THE GIBSON

A NEW FREMONT RESIDENTIAL
APARTMENT BUILDING

3421 & 3422 WOODLAND PARK
AVE N, SEATTLE WA
3032609-EG
3029623-LU

RECOMMENDATION
MEETING: MONDAY, NOVEMBER 23RD, 2020

^ EDG Diagram of Massing Articulation

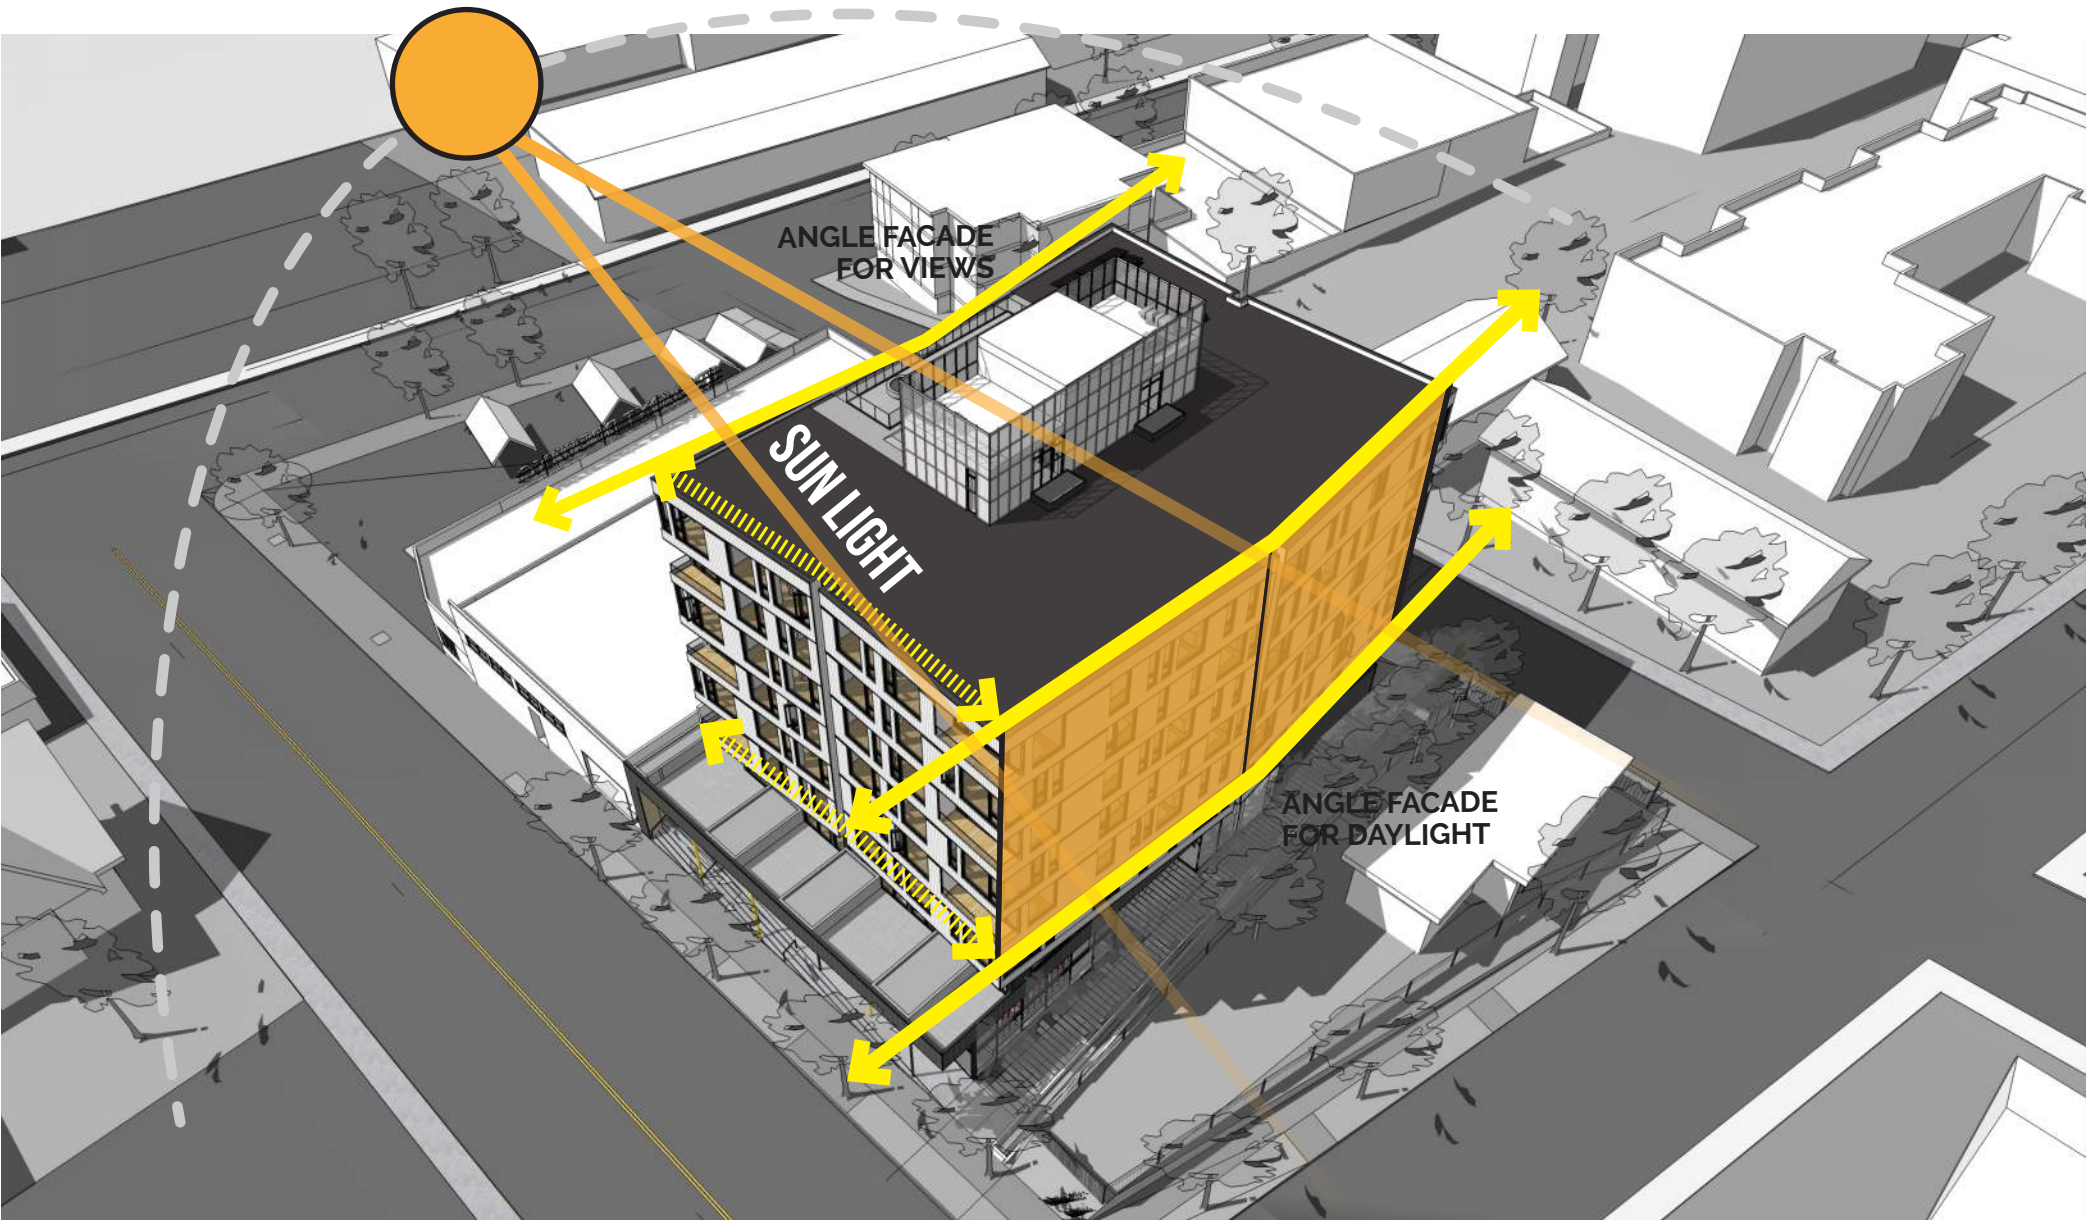
- a. The Board unanimously supported Option B3, the applicant's preferred massing option, as it is highly responsive to the present and future context, neighboring structures, and unique perimeter conditions. (CS2)

- b. The Board supported the subtle and sophisticated sculpting of Option B3, and stated it appears to be light and fun in comparison to the blocky and conventional form of options B1 and B2. In agreement with public comment, the Board encouraged further development of the overall architectural character in a manner that expresses the whimsy and quirkiness of the Fremont neighborhood and specifically prioritized Design Guideline CS2-A, Location in the City and Neighborhood, and CS3A, Emphasizing Positive Neighborhood Attributes. (CS2-A, CS3-A)

The massing scheme from the EDG has been maintained and the angular shape of the massing is preserved in order to provide sunlight to the north neighbor and create opportunities for views along the south. Additionally, the angular shape and sculptural form of the building enhance the artistic vibes of the Fremont neighborhood allowing the building to establish a sense of place along the neighborhood block. CS2-A (Sense of Place and Architectural Presence)

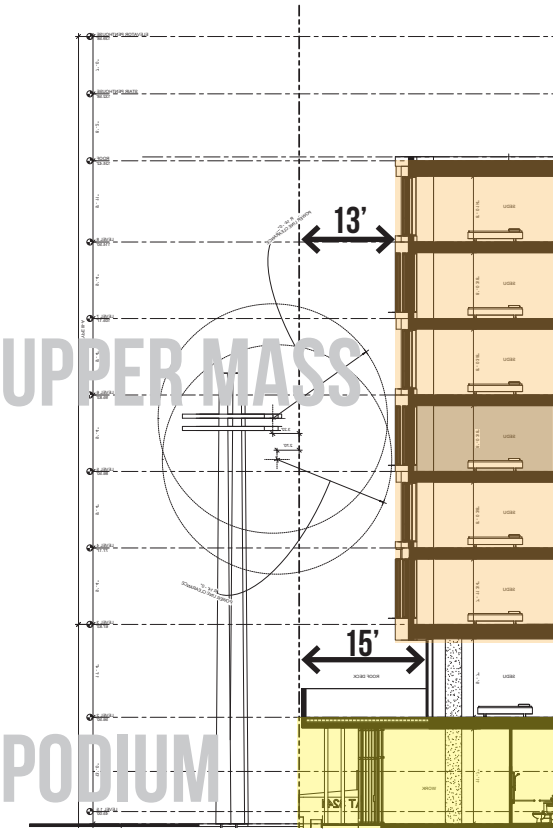
e. The Board supported the response to the existing commercial datum to the south along Woodland Park Ave N and the resulting upper-level setback above the live/work units. (CS2-B, CS3-A-1, DC2-A-1)

f. The Board specifically prioritized PL3-A, Entries, and PL3-B, Residential Edges. (PL3A, PL3-B)

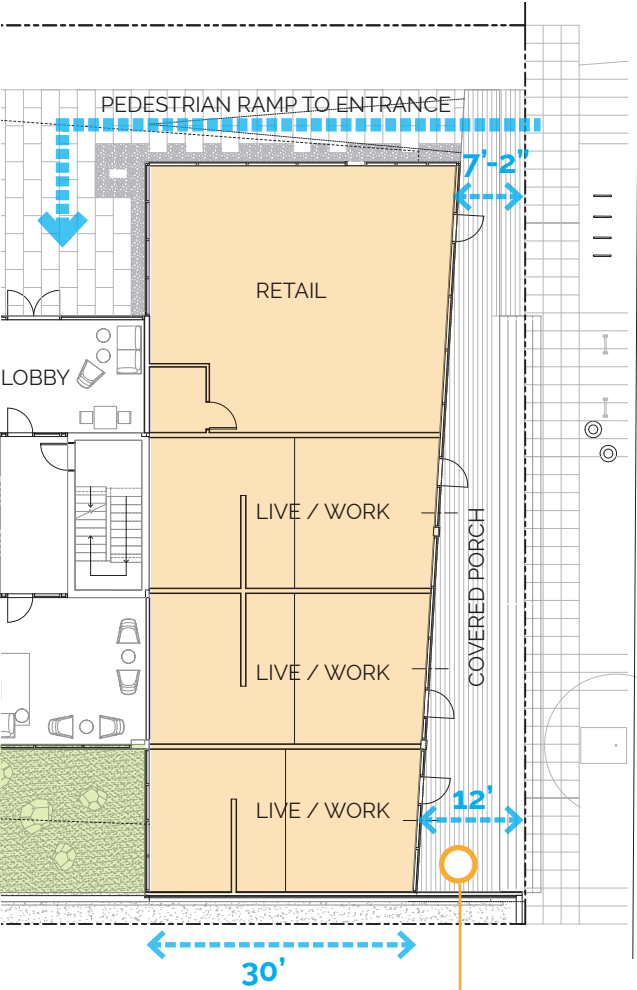
The board supported the location of the live/work units and the transition between existing commercial use and the residential use. The board provided guidance to contribute to the pedestrian realm.

The proposed location of the live/work units and retail program have been maintained at the northeast corner of the site providing a good transition between the existing commercial spaces on the north and south and the new residential structure.

To enhance the sense of pedestrian activation along these units, an angle was created (*akin to the angles along the upper level mass*) along the ground plane that expands the depth of the covered porch area under the building overhang. This area will allow for spill out space and informal gathering opportunities along Woodland Park Ave N.

The live/work unit depths have been re-configured to ensure the 30' required commercial depth (15' min for the business portion of the unit), so no departure is needed, though the secondary entrances from the west have been eliminated in an effort to provide needed egress and exiting and a courtyard space off the south lobby.

^ EDG Diagram of Albion Place N Residential Entries, Vehicular and Solid Waste Storage Access

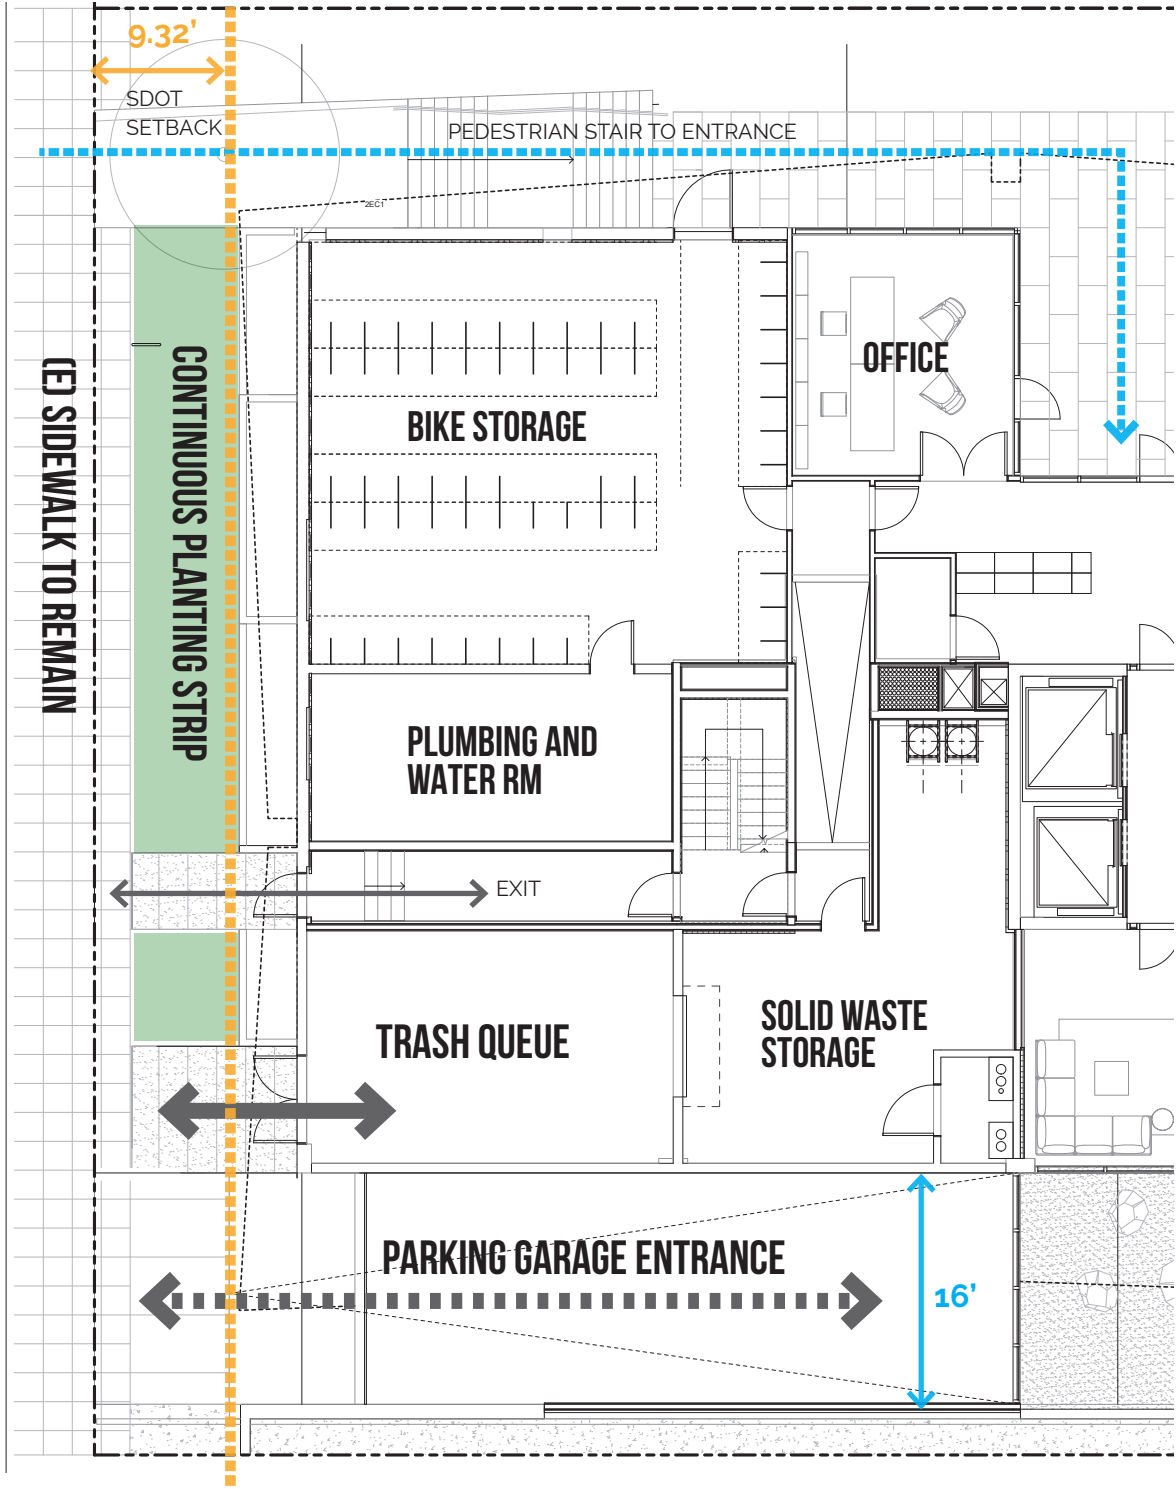
- a. The Board supported the proposed individual entries along Albion Place N as it maximizes eyes on the street. Stoops should be designed to be usable spaces and contribute to a residential character. (PL2-B-1, PL3-A-3, PL3-B, DC2-D-1)
- b. The Board acknowledged SDOT comments regarding the preferred planting strip location along Albion Place N; however, the Board noted that locating the sidewalk between the curb and the planting strip helps buffer residential units by creating a more contiguous landscape along the property line. (PL3-B, DC4-D-1)
- c. The Board supported the proposed trash storage, staging and service plans. (DC1-C)

- a. The design team evaluated the program with the client and consultant team following the Early Design Guidance meeting and determined that the ground level needed to be slightly modified in order to accommodate some additional bike storage and plumbing / mechanical rooms. Keeping with the idea of preserving the commercial base datum, the design was adapted to maintain the commercial look around the base of the structure, with landscaping and access doors for trash and the parking garage.

- c. Per design guideline PL1-A1 "Enhancing open space" the existing sidewalk condition has been left in its original place to maintain the traditional block condition and more meaningfully connect to the broader open space network that is existing. All pedestrian access has been designed to integrate with this condition and the design team agrees with SDCI regarding the larger, continuous planting strip adjacent to the building.

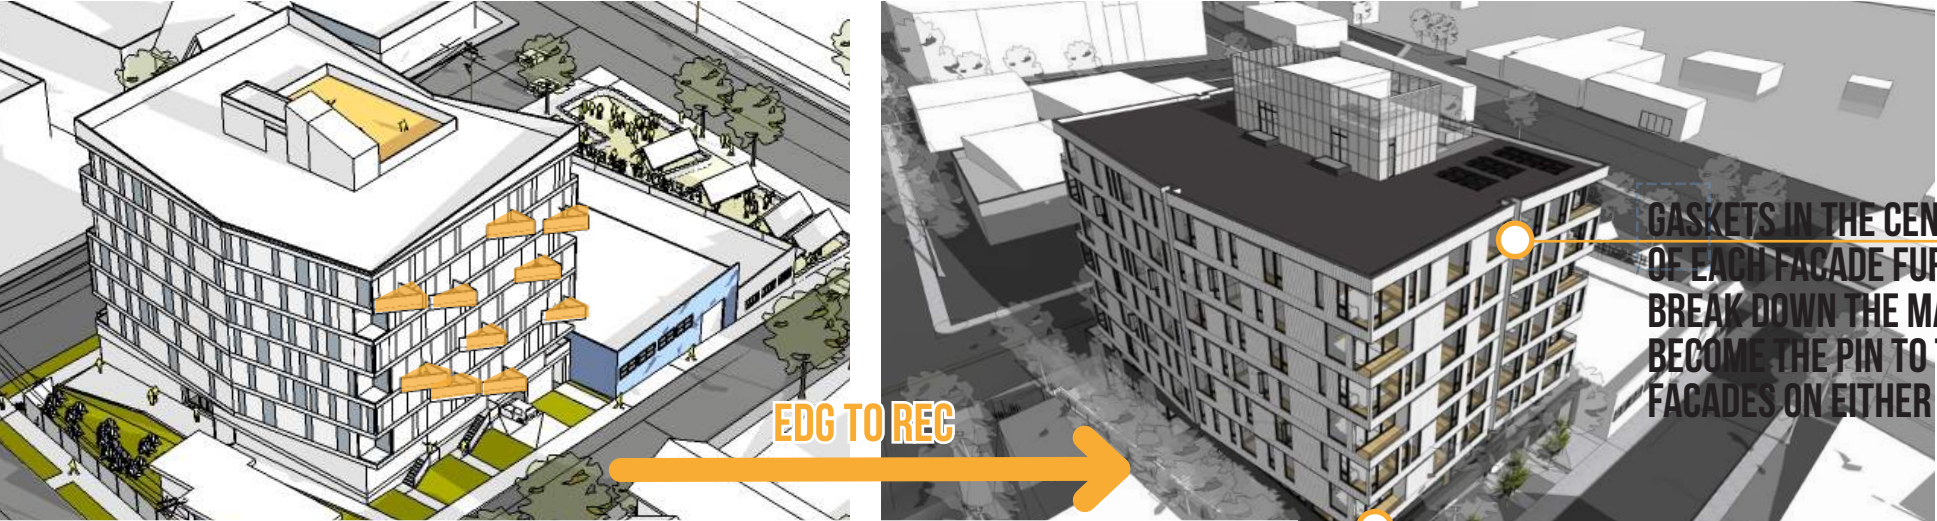
The board suggested further studies and **additions of recessed balconies** to gain advantage of the views. The board questioned the usability of the balconies on the west facade due to the size.

- a. In response to public comment, the Board directed further study of additional recessed balconies on the south facade in a manner that activates and enlivens the façade, takes advantage of views, and is consistent with the eroded corners concept. Studies should be documented at the Recommendation phase. (DC2, DC2-A-1, DC2B-1, DC2-C-1, DC2-C-2)
- b. The Board noted that the attached balconies on the west façade successfully contribute to a quirky character; however, the Board noted the balconies should be of a useable size. (CS3, DC2, DC2-C, DC3-B-1)

- a. In response to design guidance, the design team investigated approaches to further activate the south facade. Recessed balconies were staggered, similarly to the eroded corners to provide variety and visual interest while breaking up the building facade to decrease the visual weight of the mass. This integration allows opportunity for exterior living space for some units and access towards the Lake Union views.
- b. There were several limitations, including balcony functional size, which limited the use of the triangular balconies. The proposed design, thus eliminates this option in lieu of a more wholistic and continuous approach including the recessed balconies at the corner. Recessing the balconies into the building mass allows additional weather protection for use year round.

v Precedent Images from EDG packet

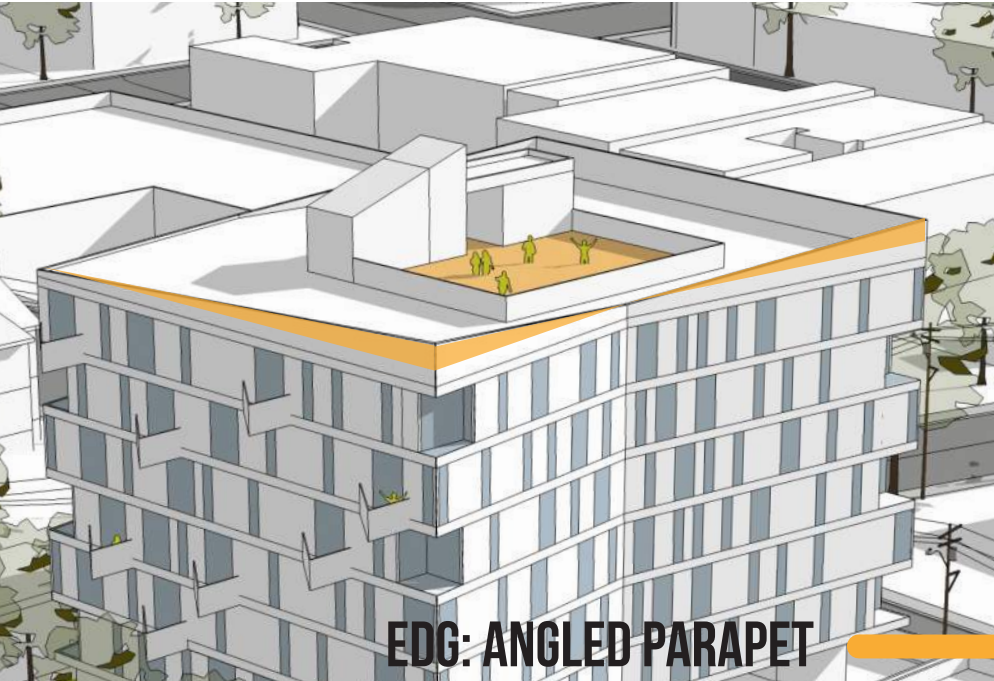
C. In agreement with public comment, the Board supported the continuous horizontal banding. The Board noted that banding should be achieved through figure/ground composition of glazing and materials, as depicted in precedent images 1 and 3 on page 35 of the EDG Packet, rather than literal horizontal material striping, as depicted in precedent image 4 on the same page. (DC2-B-1)

Response: As the design developed, the design team followed guidance to provide for a continuous horizontal design language as emphasized below on the podium and through the banding in the main white metal mass. While the darker base materials weight and ground the building, the dark windows were picked up at the top to compose the fenestration within the figure / ground methodology proposed, helping break up and further define the window openings.
